STATE OF HAWAII
DEPARTMENT OF TRANSPORTATION
HIGHWAYS DIVISION
ROADWAY PLAN
KUHIO HIGHWAY
Retaining Walls At Lumahai And Wainiha
Project No. 560A-03-96
Scale: As Shown Date: June 15, 2011
SHEET No. 501 OF 2 SHEETS

C.O. 6

STATE OF HAWAII
DEPARTMENT OF TRANSPORTATION
HIGHWAYS DIVISION
SITE 1 - GRADING PLAN
KUHIO HIGHWAY
Retaining Walls at Lumahai and Wainiha
Project No. 560A-03-96
Scale: As Shown Date: June 15, 2011
SHEET NO. C1J OF 2 SHEETS

SITE 2 - DRAINAGE PLAN AND DETAILS
KUHIO HIGHWAY
Retaining Walls at Lumahai and Wainiha
Project No. 560A-03-96
Scale: As Shown Date: June 15, 2011

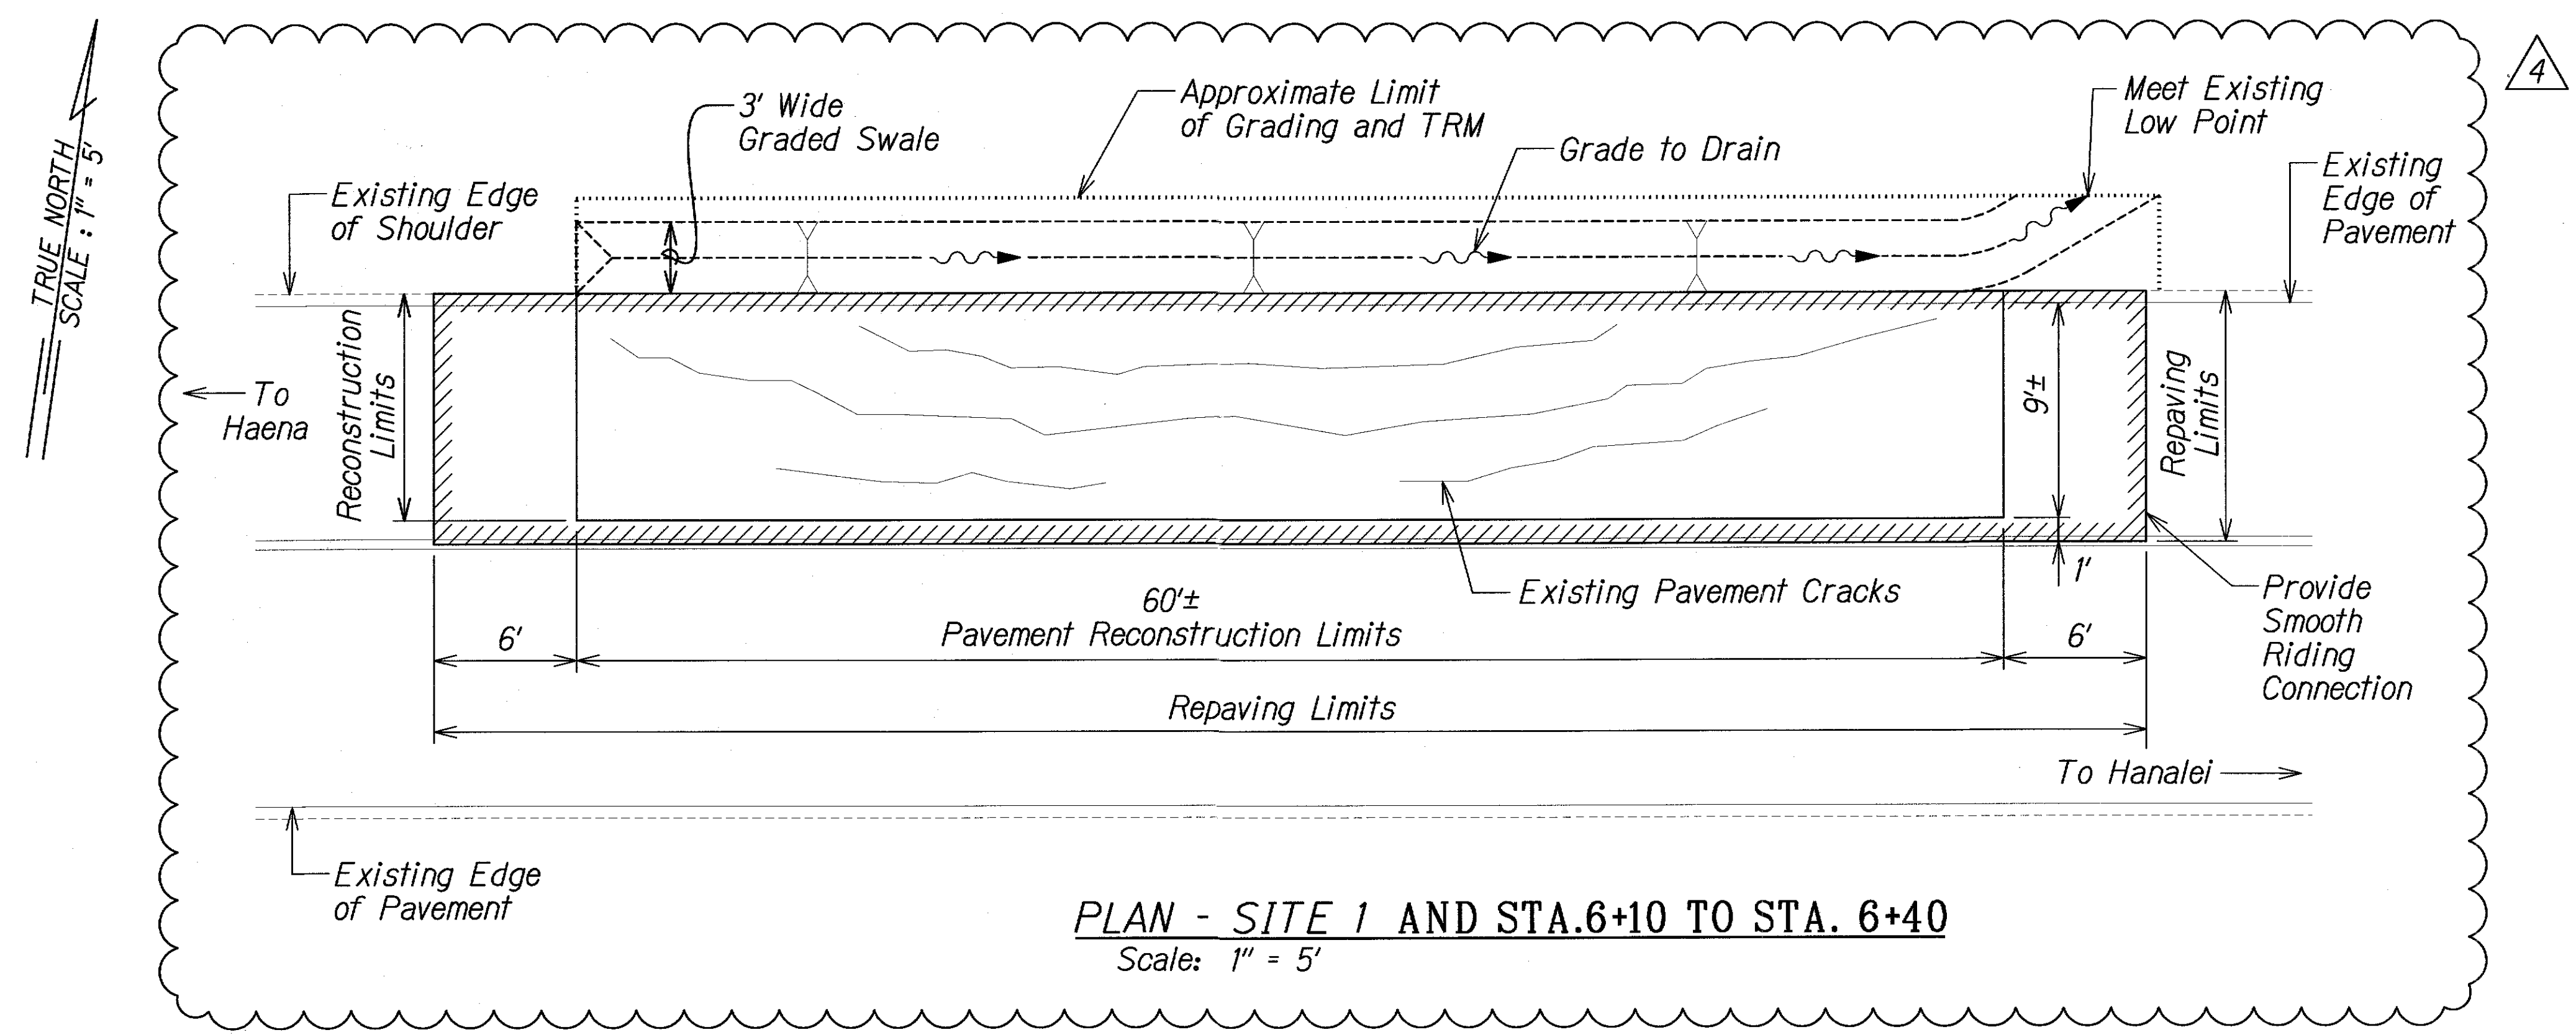
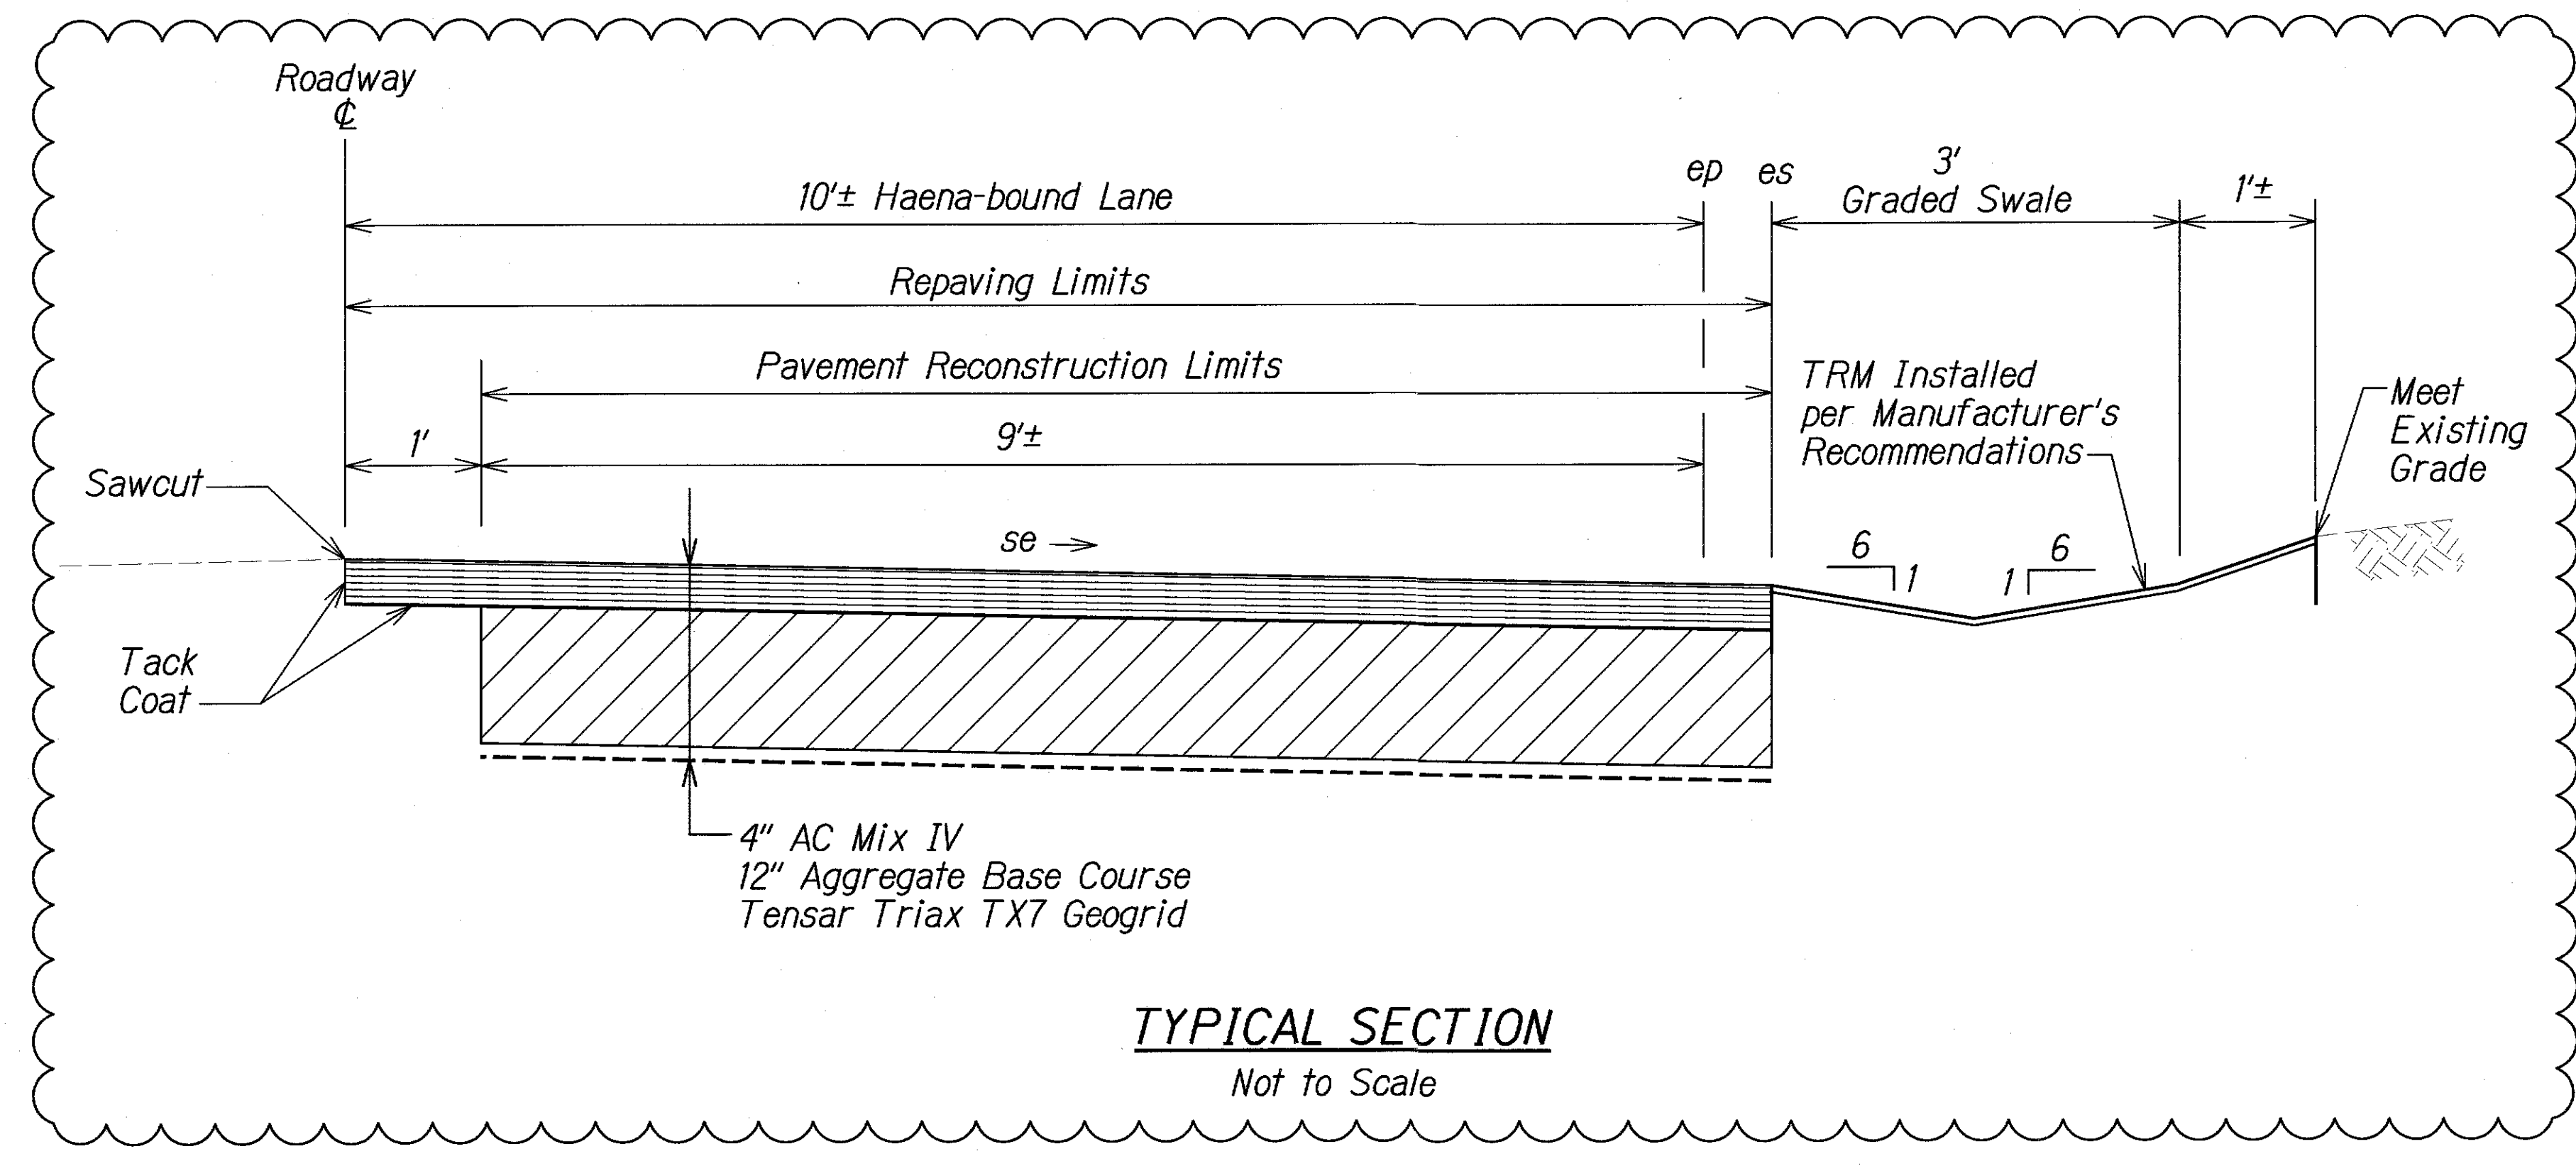
1. Turf Reinforcement Matting (TRM) shall be North American Green VMax³ C350 or equivalent.
2. Contractor shall grass the area underneath the turf reinforcement mat with vegetation matching existing condition prior to installation of the matting. Matting shall be installed within 24 hours of grassing.
3. Placement of turf reinforcement mat shall be per manufacturer's recommendations, including preparation of soil, placement procedures (roll overlaps, roll direction, contact with ground surface, staple/stake patterns, etc.), and anchoring of the ends.
4. Payment for turf reinforcement mat shall be considered incidental to the various paving items.

6/15/11	Added Note 4
5/11/11	Revised Location & Details
Date	Revision
